Round 12 - Dam Assessment Report

Big Brown Steam Electric Station

Bottom Ash Pond

Luminant Generation Co., LLC

Figure 6: North Pond Embankment (Note geotextile separation and erosion).

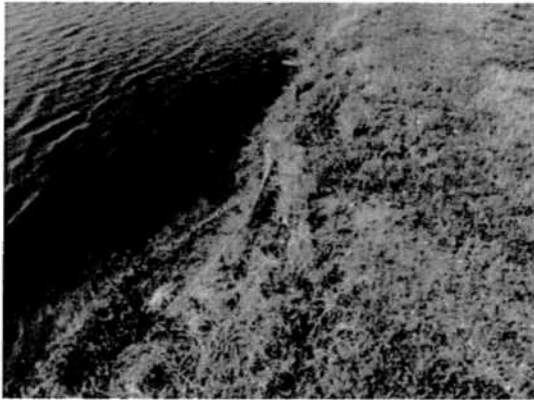
MODERATE ITEM: Wave erosion was observed on the North Pond (Figure 6). Erosion matting was installed to mitigate the erosion along the upstream embankments of both ponds. The matting installed in the North Pond did not appear to be functioning as well as the matting installed on the South Pond (Figure 7). The North Pond was emptied in 2011 and repairs were made to the liner and protective cover. The South Pond was emptied and repaired in 2009.

Recommendation 2: Continue to monitor erosion to protective cover over liner and repair as needed with riprap.

Figure 18: North Pond Pipe Rack Erosion

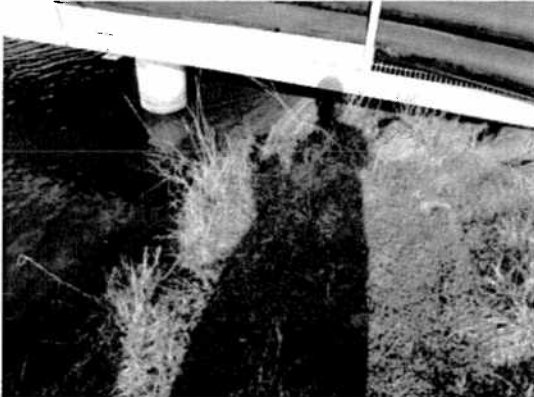
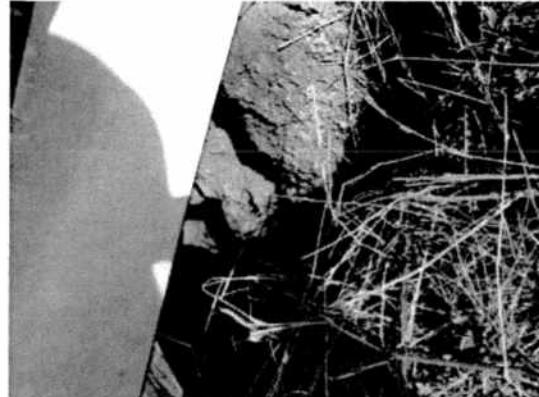
Figure 19: North Pond Pipe Rack Erosion

Recommendation 3: Continue to monitor areas after repairs for additional erosion.
